Service Bulletin

Bulletin No.: 18-NA-054

Subject: Momentary Sharp Deceleration During 1-2 Upshift or a Momentary Neutral During 2-4 Upshift, Transmission Stuck in 2nd Gear (fluid below 32°F), Malfunction Indicator Lamp (MIL) Illuminated - DTC P2820 and/or P2821 Set During Cold Ambient Temperatures

4885522

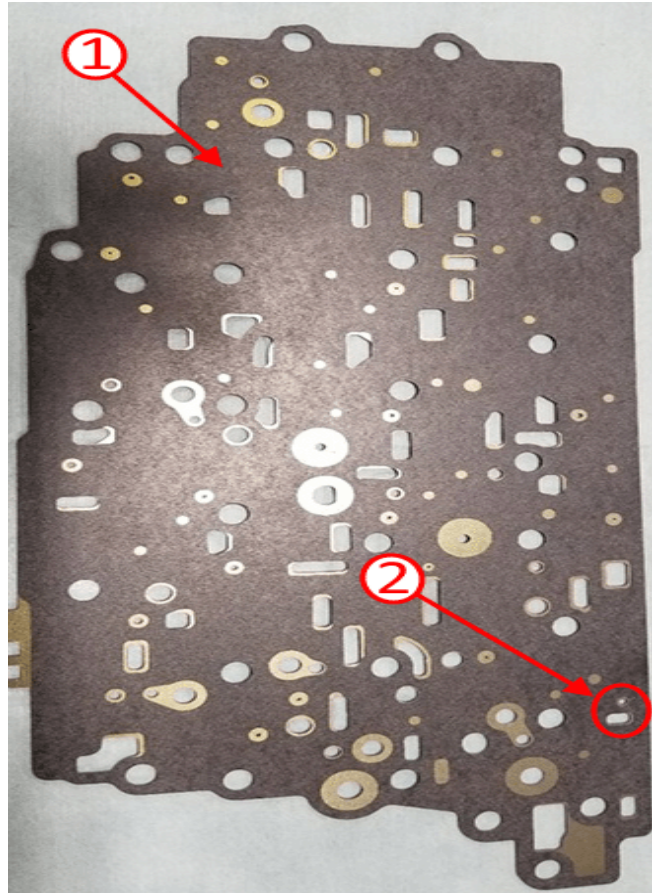
This condition may be caused by the spacer plate (1), located between the valve body and the transmission case, containing an undersized orifice (2).

⇒ The consequence is the clutch select moves slowly to release the selectable one way clutch, which causes a momentary transmission tie up during the 1-2 upshift.

Correction	Inspect the valve body spacer plate orifice for proper size and replace as necessary following current SI instructions.  4885518 • If the hole is 0.5 mm, replace the spacer plate.  4885520 • If the hole is 2.0 mm, refer to SI for further diagnostics.
-------------------	---
